**HYUNDAI**
Technical Service Bulletin

GROUP RECALL	NUMBER 18-01-011
DATE FEBRUARY, 2018	MODEL(S) Santa Fe Sport (AN) Santa Fe (NC)

SUBJECT: 2018 SANTA FE SPORT (AN) AND SANTA FE (NC) STEERING WHEEL INSPECTION AND REPLACEMENT (RECALL CAMPAIGN 173)

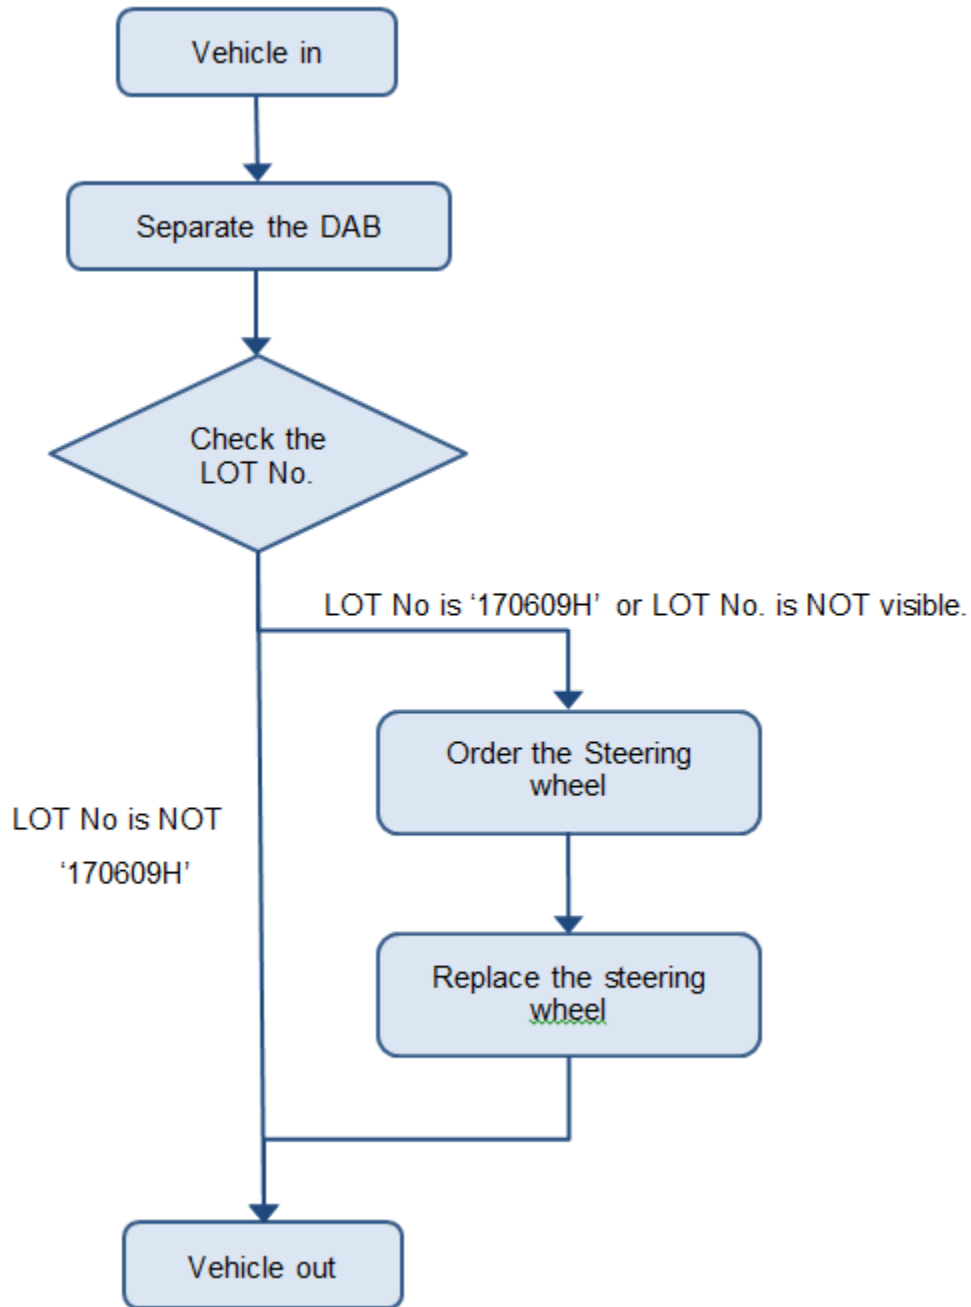
3. Raise the driver airbag module (A) and inspect the LOT No. (B).

4. If the LOT No. (C) is '170609H' or does not have a Lot No., replace the steering wheel per the 2018 Santa Fe Sport or Santa Fe Service Manual (Steering System>Steering Wheel).

5. If the LOT No. (C) is not '170609H', reinstall all removed parts in reverse order of removal and finish the service procedure.
